Sub station in the car park at Crazy Prices Shop, Hillcrest Estate, Lucan for Power Supermarkets Ltd.

Reg. Ref. 91A/2083  
COMP. REC'D: 22.06.92

Report of the Dublin Planning Officer, dated 25 June 1992.

This is a submission for COMPLIANCE with Condition No. 4 of decision to Grant Permission by Order No. P/0745/92, dated, 19th February, 1992, in connection with the above.

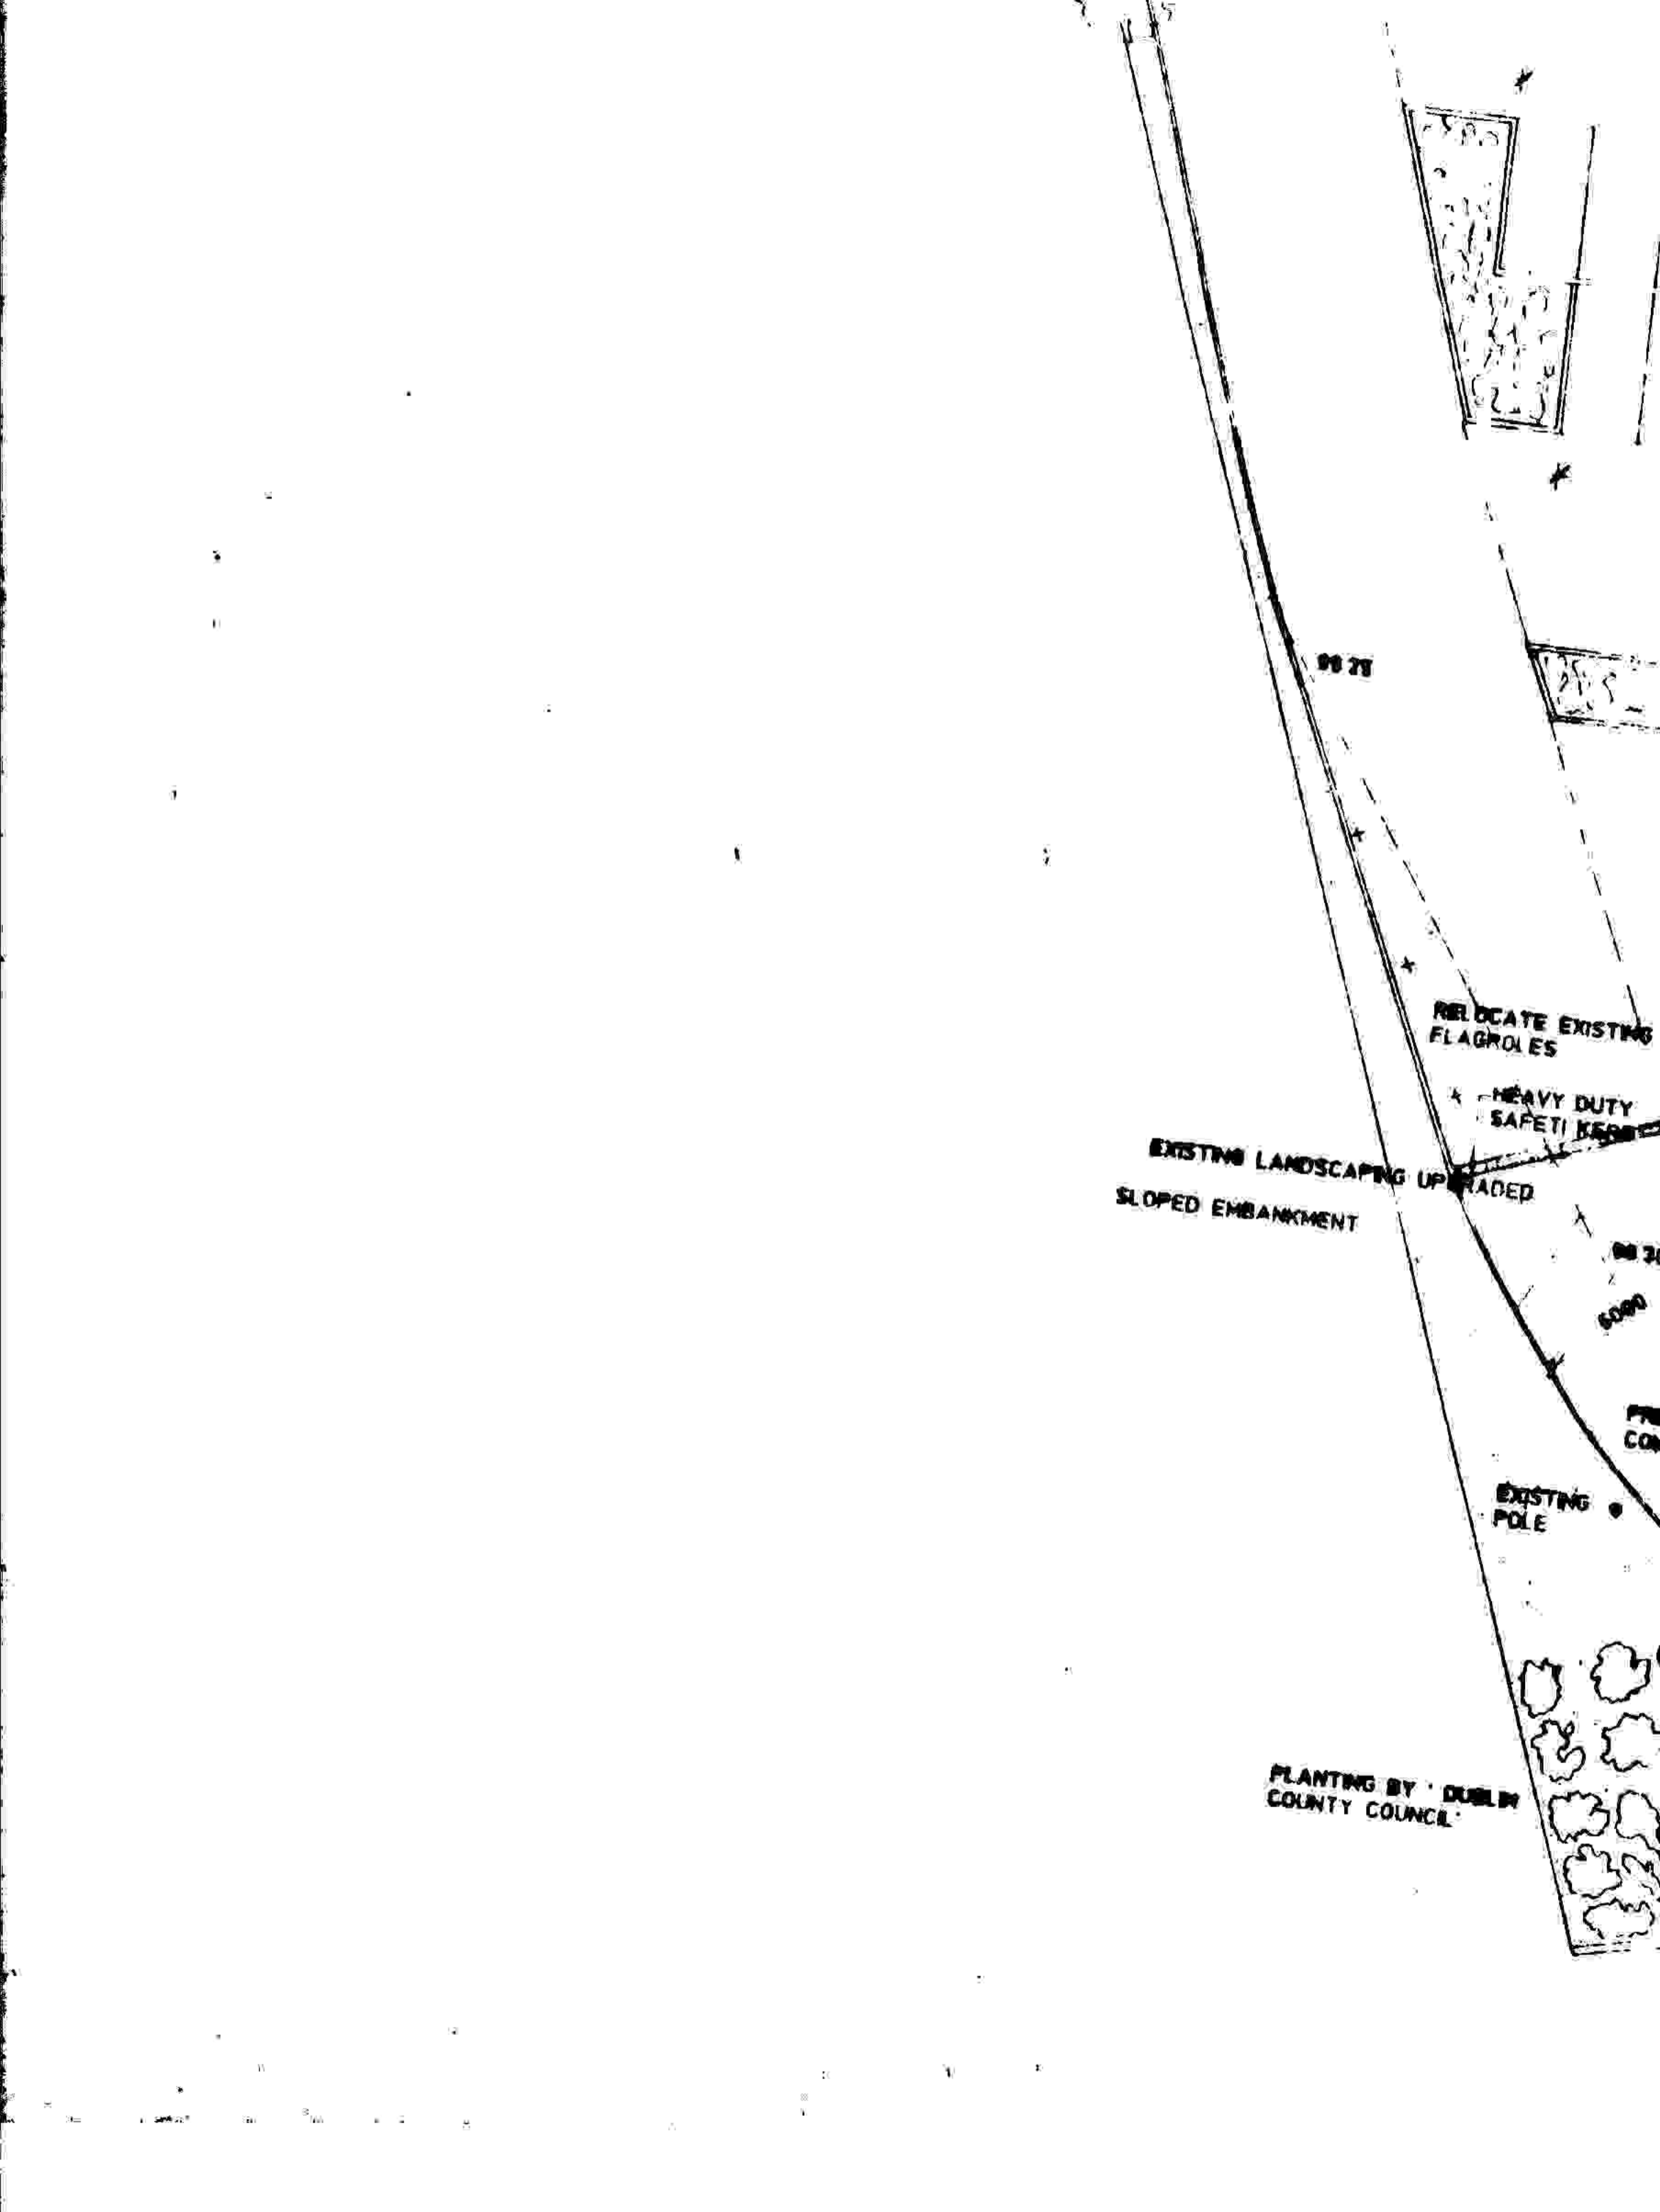
"The location of the proposed sub-station to be revised to eliminate impact on the adjoining dwelling house/garden. Drawings showing necessary revisions to be submitted to the Planning Authority for agreement".

04 The location of the proposed sub-station to be revised to eliminate impact on the adjoining dwelling-house garden. Drawings showing necessary revisions to be submitted to the Planning Authority for agreement.

Revised drawings were submitted on 22/6/92. These show the substation relocated to the north eastern boundary of the site with the Lucan By Pass.

The revised proposal is considered acceptable. I recommend that the applicants be informed accordingly.

Please find enclosed 3 copies of our drawing no QW29-11A showing new location for the above sub station. This location has been carefully chosen so as not to interfere with existing underground services (HT Cables) and eliminate impact on nearby housing.
